## **NOTICE OF MEETING**

**Agenda for a Planning Authority Committee meeting of the Devonport City Council  
held on Monday 1 March 2021, in the Aberdeen Room, Level 2, paranaple centre,137  
Rooke Street, Devonport at 5:15 PM**

### 4.1 AM2020.03 & PA2021.0227 - COMBINED AMENDMENT - AMEND CLAUSE DEV-S1.6.1 A2 (A) OF THE TASMANIAN PLANNING SCHEME - DEVONPORT TO ALLOW FOR A REDUCED FLOOR AREA FOR FOOD SERVICES AND APPLICATION FOR FOOD SERVICES

Figure 11 - Plan showing location of proposed signs. Signs visible outside the site are circled in solid red. Signs only visible within the site are circled with a dashed red line.

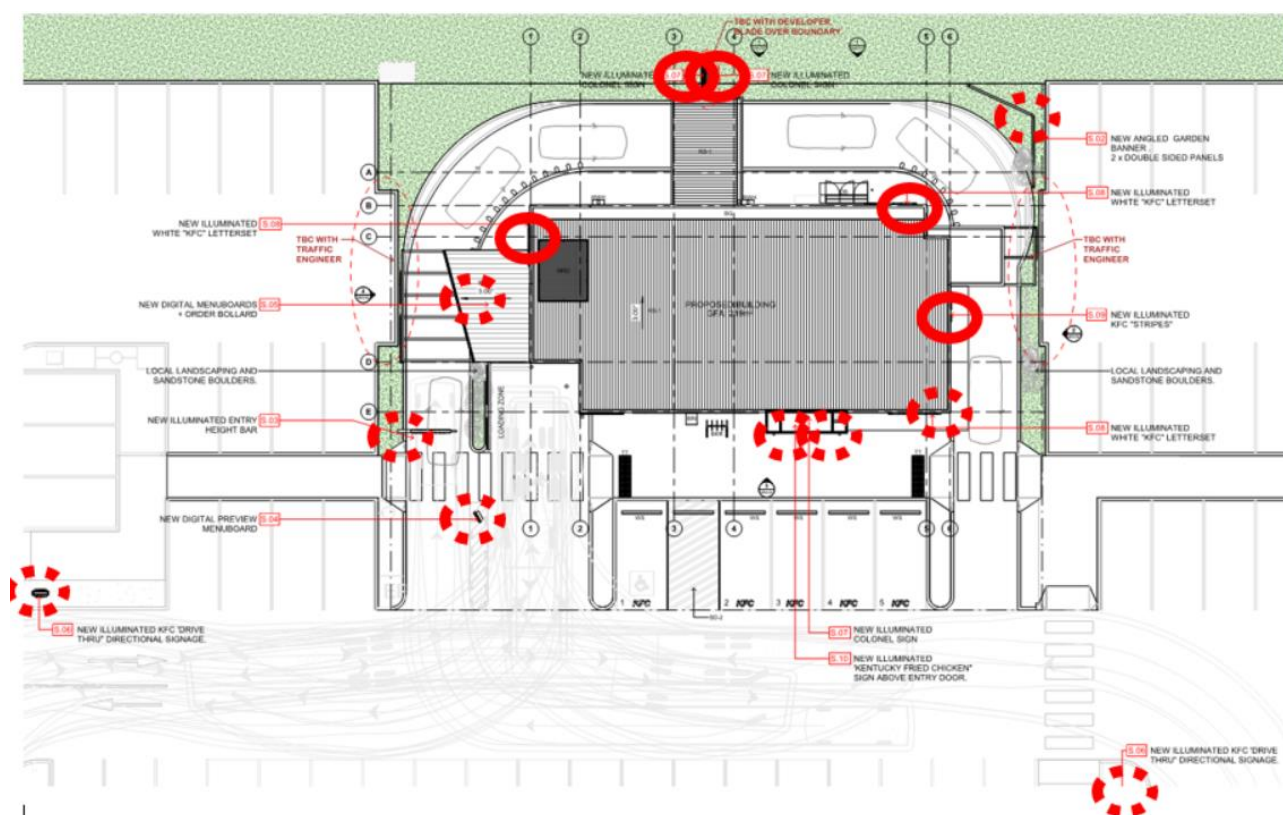
Comment – A1 – The sign proposed within the setback area from the Bass Highway frontage is not permitted as this would increase the number of signs within this area to 4. A condition will be placed on the permit requiring the sign be removed from the plans.

Figure 11 shows the location of the proposed signs for the premises marked in red. Those with a solid red circle are visible from outside the site while those with a dashed red circle are only visible, or intended to be visible, from within the site.

Comment – In accordance with C1.4.2 above the signage proposed that cannot, or is not intended to be, seen from outside the site is exempt (see Figure 11).

2. Approval is not granted for the proposed pylon sign within the setback area of the Bass Highway frontage.
  3. Landscaping to a depth of not less than 5.5m must be provided along the frontage of the tenancy prior to the building permits being finalised.
